Subject: Fuel Leak Case No. RO0002438, Chevron #9-2029, 890 West MacArthur Blvd.,
Oakland, CA 94608

Alameda County Environmental Health (ACEH) staff has received and reviewed the August 31, 2006 Well Destruction and Installation Workplan by Cambria. This work plan proposes the proper well decommissioning of monitoring wells MW-1 through MW-4 and the installation of four new wells along the sidewalks down-gradient of this site as indicated in Figure 2 within this report. We approve this work plan and request you observe the following technical comment when performing this work and submit the technical reports requested below.

Alameda County Environmental Health (ACEH) staff has recently reviewed the case file for the subject site including the September 19, 2005 *Investigation Workplan*, prepared by Cambria Environmental. This work plan responds to the County's prior August 26, 2005 letter. We request that you address the following technical comments, perform the proposed work, and send us the technical reports requested below.

2

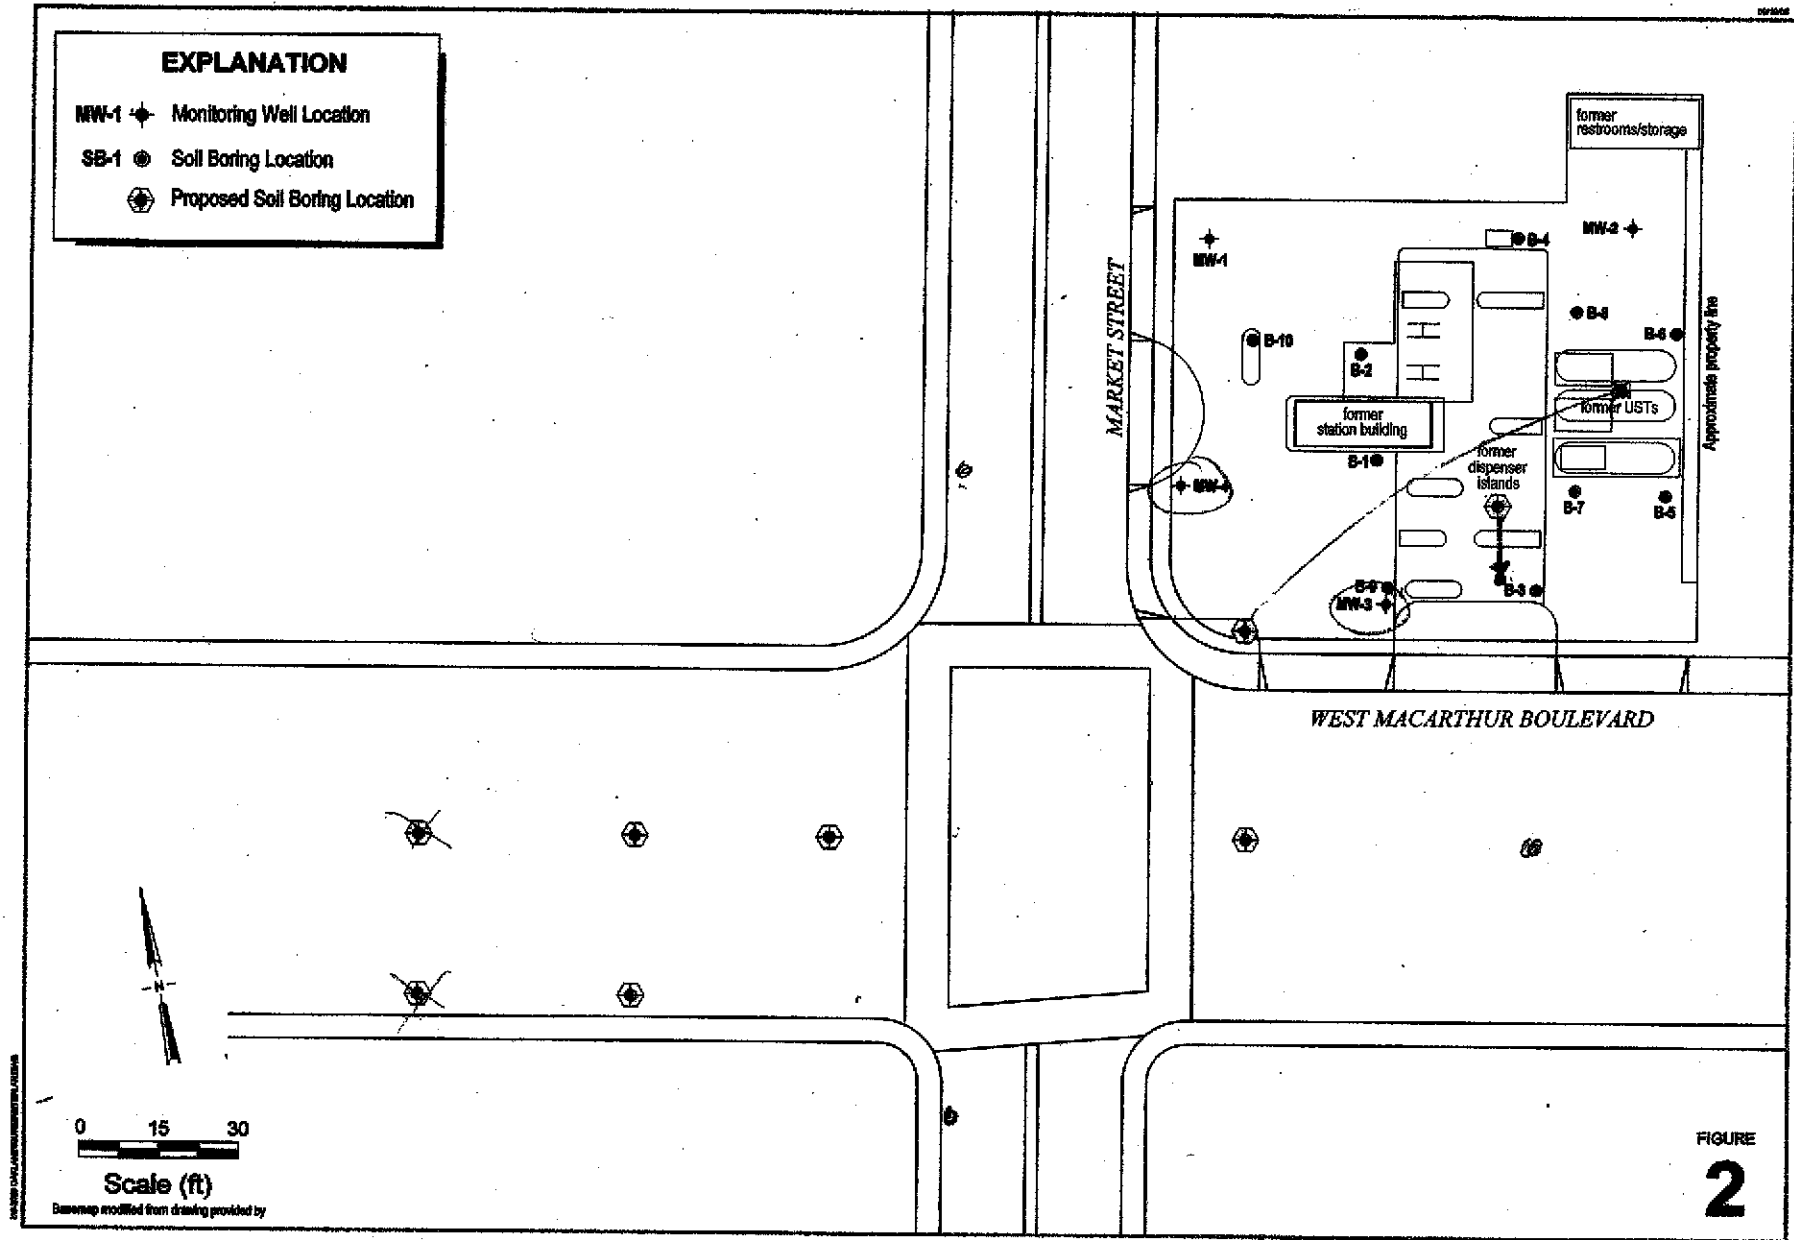
2. **Contaminant Plume Definition-** The work plan proposes advancing eight (8) Geoprobe borings down-gradient of wells MW-3 and MW-4, the current most impacted wells at the site. One of the borings is proposed down-gradient of the former UST pit, where the highest soil concentrations were found. Three depth discrete groundwater samples are proposed to determine the three dimensional characteristics of the plume. We approve this work with the following recommended changes.

- The locations of the borings should be omitted or changed according to the attached figure 2. The recommended changes include omitting the two westernmost borings, adding three additional borings to define the north, south and east edges of the plume, moving one boring closer to EX28, the highest post-excavation sample and moving one boring into the former tank pit, formerly not sampled.
